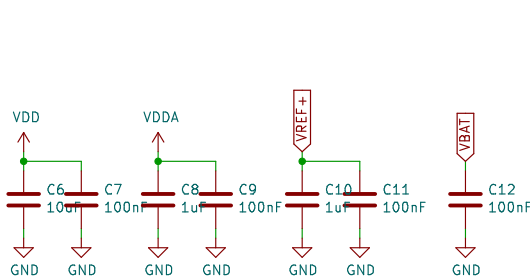
Can likely remove some of these jumpers

PAD is disconnected need to connect with solder!

SCL is not connected

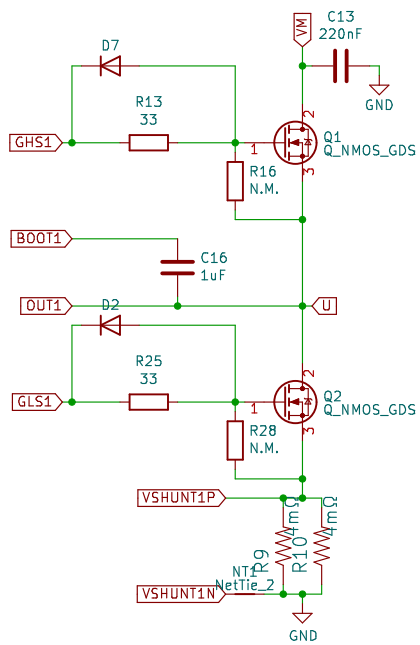
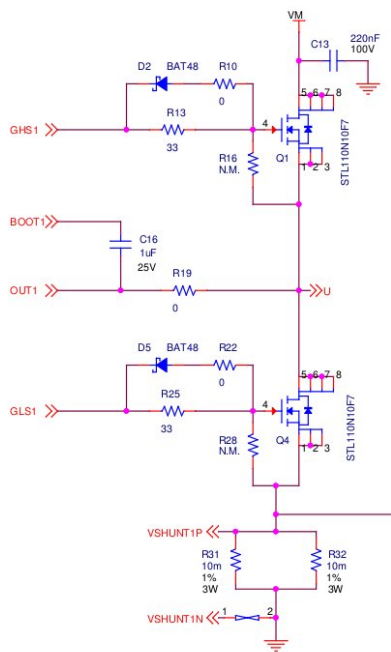
Have removed jumpers for space

Replace jumper with pass throughg

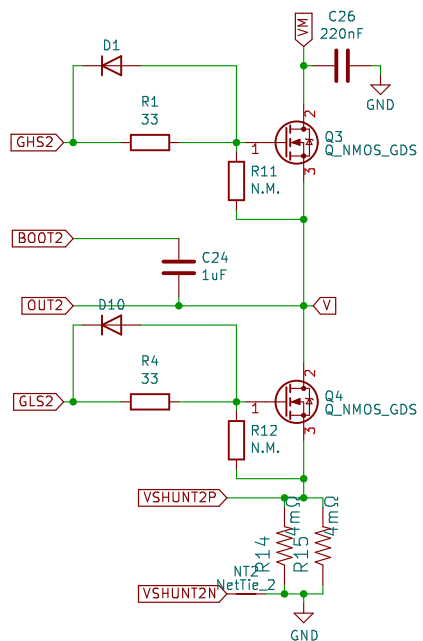
Replace jumper with pass throughg

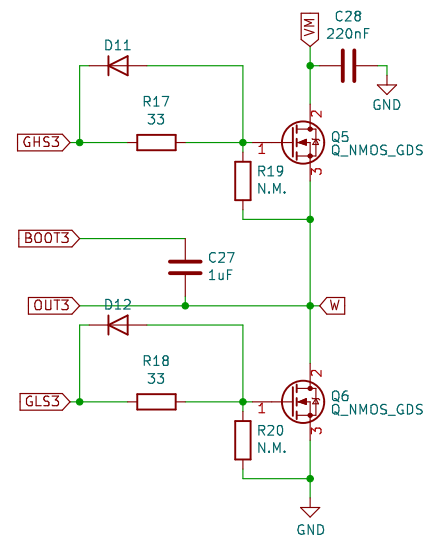
Replace jumper with pass throughg
